R20TS0896EJ0100

RX Family

Flash Module Using Firmware Integration Technology

1. Notes on the Application Note Sections "5.3.1.1 Programming Code Flash from RAM" and "5.3.1.2 Programming Code Flash Using the Dual Bank Function"

1. 5.3.1.1 Programming Code Flash from RAM

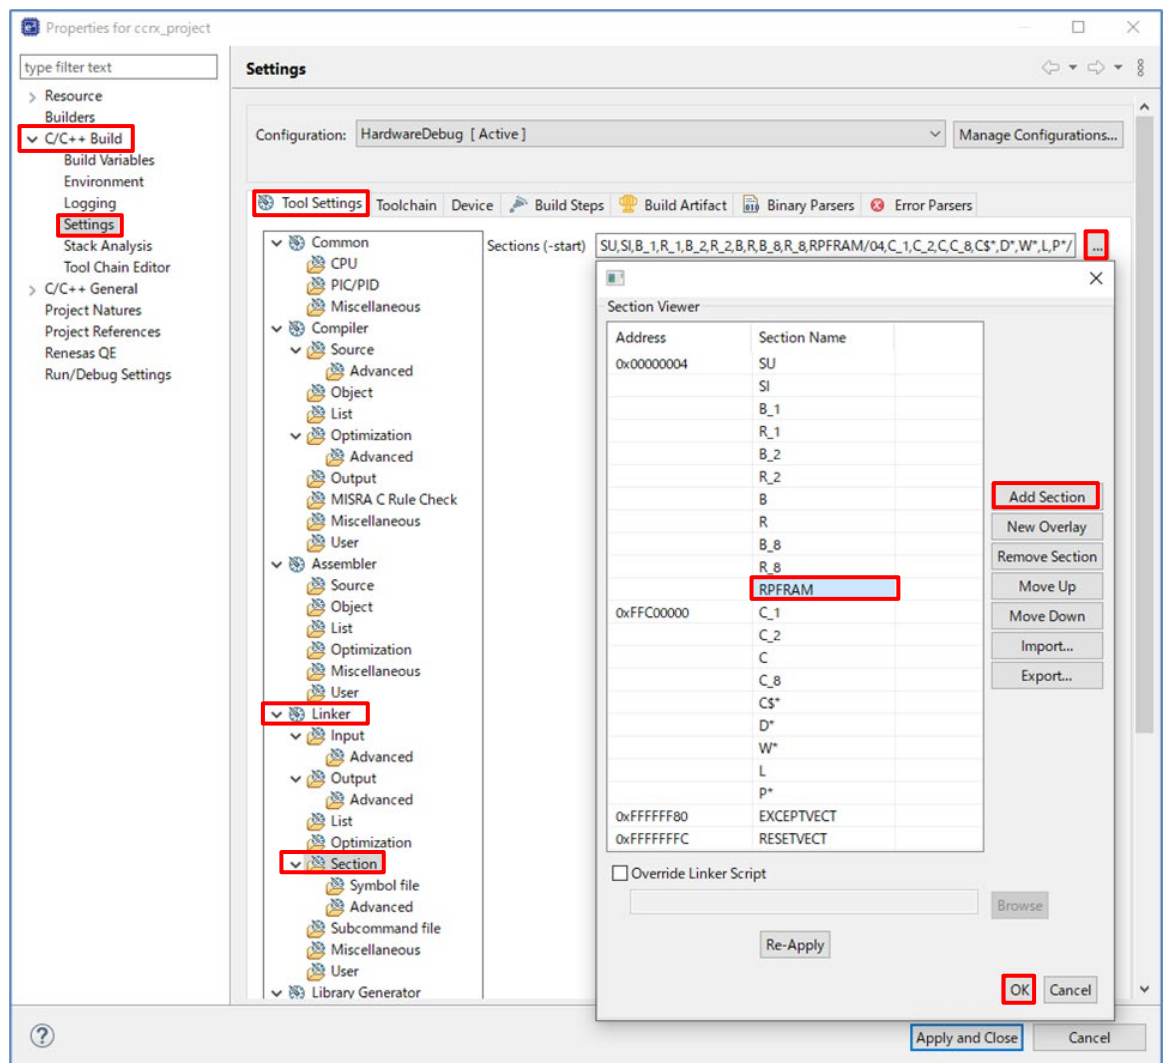
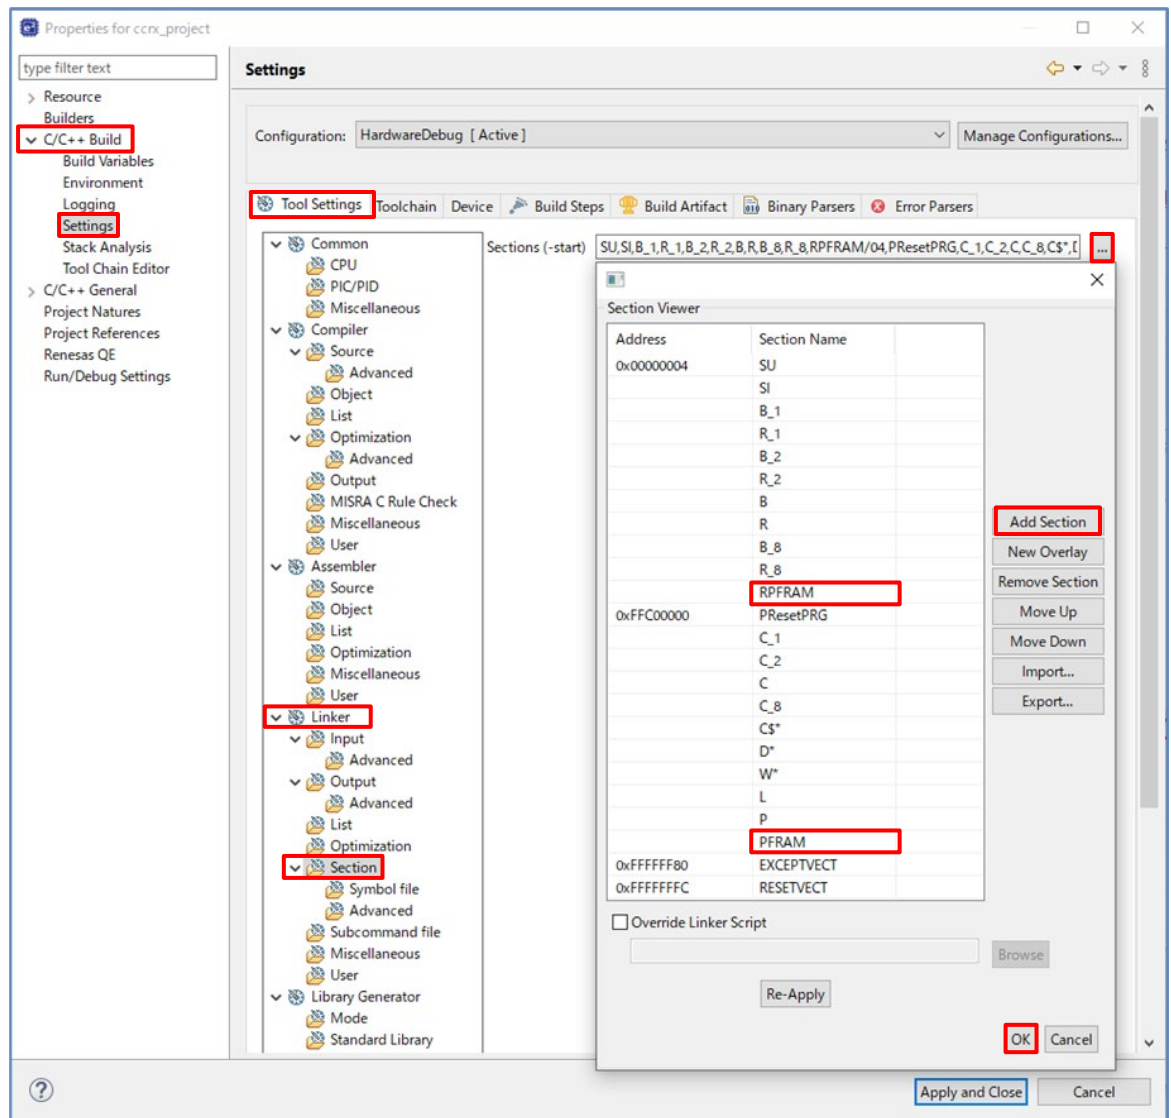
The application note for RX Family Flash Module Using Firmware Integration Technology (R01AN2184) sections 5.3.1.1 and 5.3.1.2 show inaccurate procedures.

See the application note for Flash Module Rev. 4.90, page 84, "1. Add a 'RPFRAM' section in a RAM area". Change the procedure as follows.

- (1) In Project Explorer, click the project you want to debug.
- (2) Click File > Properties to open the Properties window.
- (3) On the Properties window, click C/C++ Build > Settings.
- (4) Select the "Tool Settings" tab, click Linker > Section, and click the [...] button to display the Section Viewer window.
- (5) On the Section Viewer window, click the [Add Section] button to add a 'RPFRAM' section in a RAM area, and then click the [OK] button.

- (1) In Project Explorer, click the project you want to debug.
- (2) Click File > Properties to open the Properties window.
- (3) On the Properties window, click C/C++ Build > Settings.
- (4) Select the "Tool Settings" tab, click Linker > Section, and click the [...] button to display the Section Viewer window.
- (5) On the Section Viewer window, click the [Add Section] button to add a 'RPFRAM' section in a RAM area.
- (6) On the Section Viewer window, click the [Add Section] button to add a 'PFRAM' section in a ROM area, and then click the [OK] button.**

2. 5.3.1.2 Programming Code Flash Using the Dual Bank Function
See the application note for Flash Module Rev. 4.90, page 86, "1. Add a 'RPFRAM2' section in a RAM area". Change the procedure as follows.

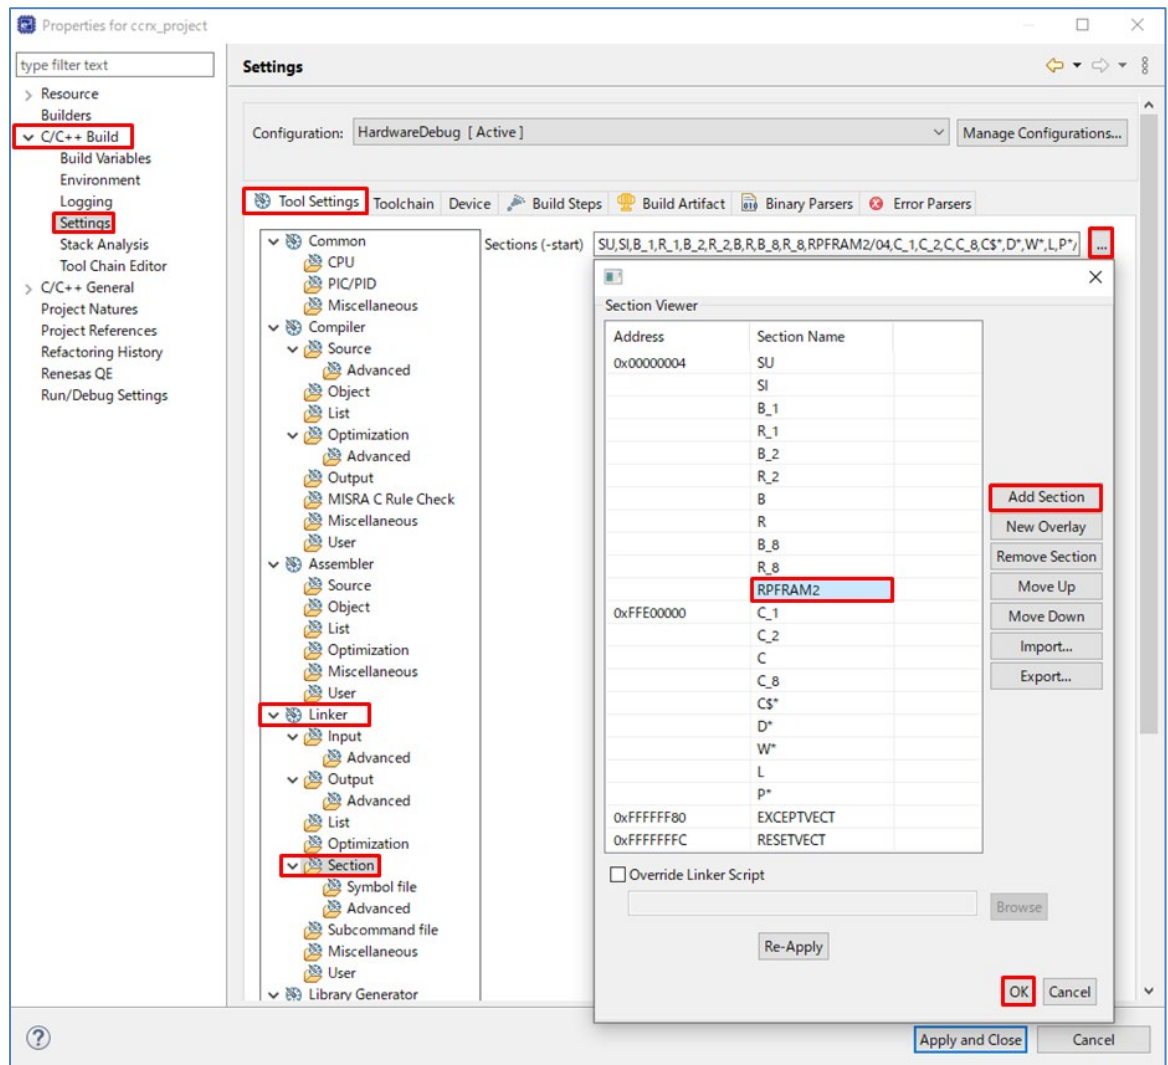
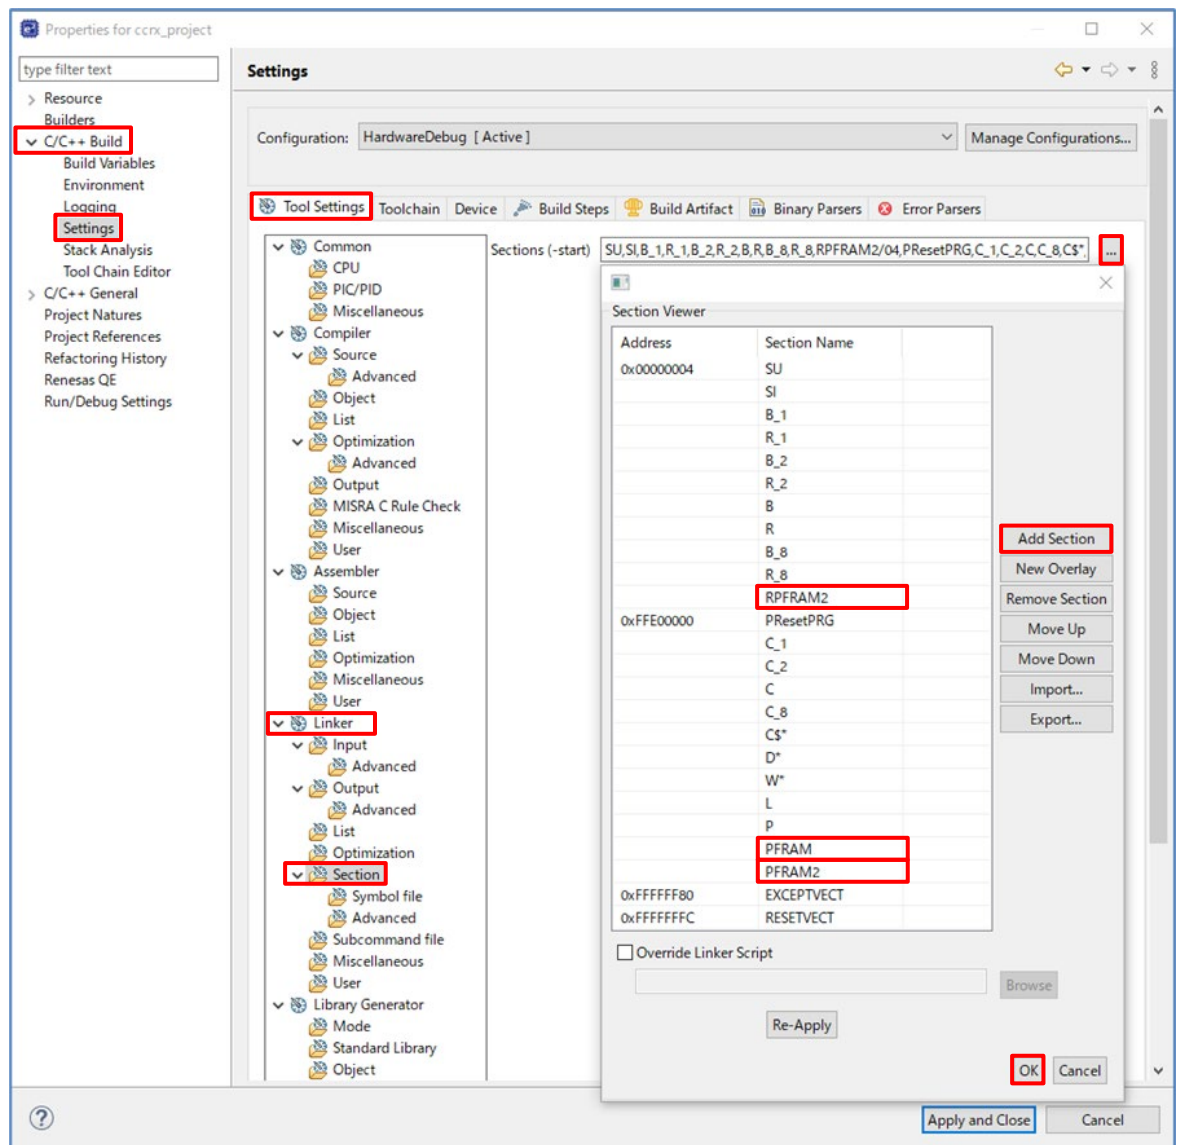
1. Add a 'RPFRAM2' section in a RAM area.
 - (1) In Project Explorer, click the project you want to debug.
 - (2) Click File > Properties to open the Properties window.
 - (3) On the Properties window, click C/C++ Build > Settings.
 - (4) Select the "Tool Settings" tab, click Linker > Section, and click the [...] button to display the Section Viewer window.
 - (5) On the Section Viewer window, click the [Add Section] button to add a 'RPFRAM2' section in a RAM area, and then click the [OK] button.

- (1) In Project Explorer, click the project you want to debug.
- (2) Click File > Properties to open the Properties window.
- (3) On the Properties window, click C/C++ Build > Settings.
- (4) Select the "Tool Settings" tab, click Linker > Section, and click the [...] button to display the Section Viewer window.
- (5) On the Section Viewer window, click the [Add Section] button to add a 'RPFRAM2' section in a RAM area.
- (6) On the Section Viewer window, click the [Add Section] button to add a 'PFRAM' section in a ROM area.
- (7) On the Section Viewer window, click the [Add Section] button to add a 'PFRAM2' section in a ROM area, and then click the [OK] button.
